Los Angeles Regional Water Quality Control Board

October 6, 2023

SUBJECT: REVIEW OF A TECHNICAL MEMORANDUM - PURSUANT TO CALIFORNIA WATER CODE SECTION 13304 CLEANUP AND ABATEMENT ORDER NO. R4-2021-0079

SITE: SKYPARK COMMERCIAL PROPERTIES (ASSESSOR PARCEL NO. 7377-006-906), 24701 – 24777 CRENSHAW BOULEVARD AND 2530, 2540, AND 2600 SKYPARK DRIVE, TORRANCE, CALIFORNIA (SCP NO. 1499, GLOBAL ID NO. T10000014333)

Attachment 1 - Figure 2 – TCE concentrations in Regional Groundwater

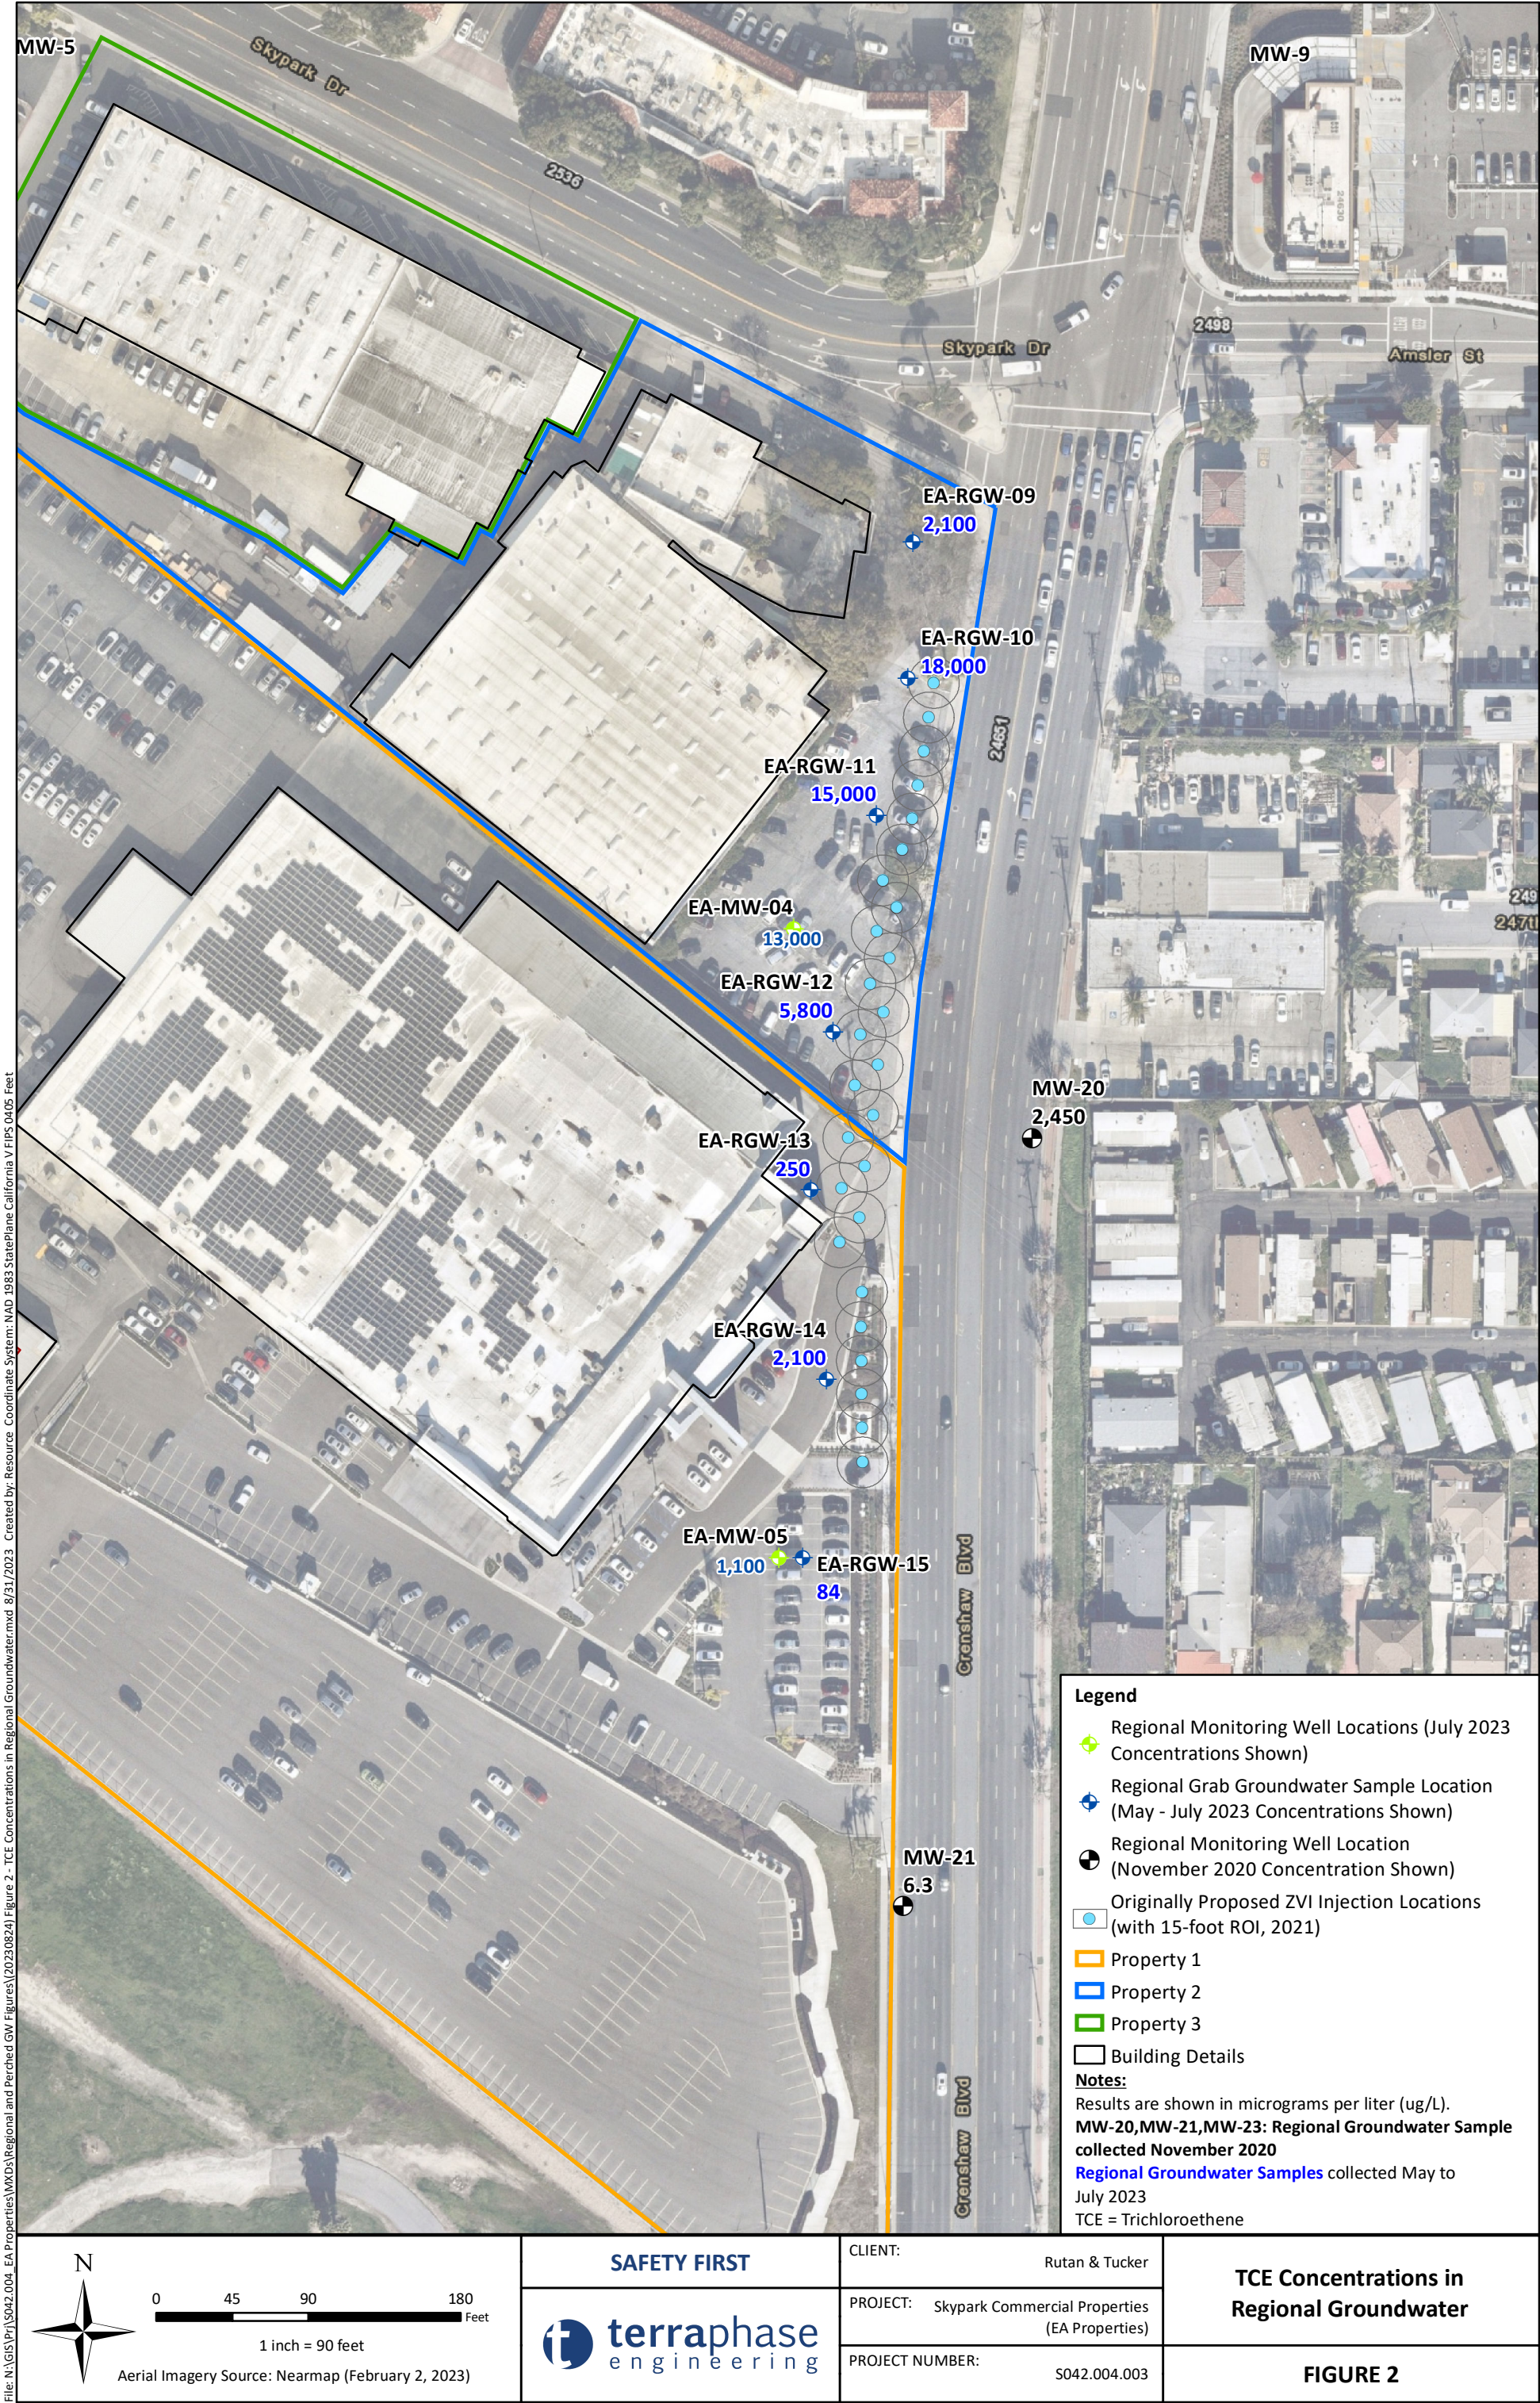
- a. TCE was detected up to 18,000 micrograms per liter (µg/L) (detected in regional grab groundwater sample EA-RGW-10), as shown in Attachment 1, *Figure 2 – TCE concentrations in Regional Groundwater* (Figure 2).

- i. The additional multi-nested groundwater monitoring well(s) must be installed in the immediate vicinity of regional grab groundwater sample EA-RGW-10 (i.e., where the highest TCE and total chlorinated VOCs concentrations were detected [from the recent collected environmental data proximal to the ZVI barrier collected as part of the investigative component of the Revised EAP IRAP]).

- i. Two of the multi-nested groundwater monitoring wells must be installed north of groundwater monitoring well MW-20 to be downgradient of and roughly mirror regional grab groundwater samples EA-RGW-09, EA-RGW-10 and EA-RGW-11.
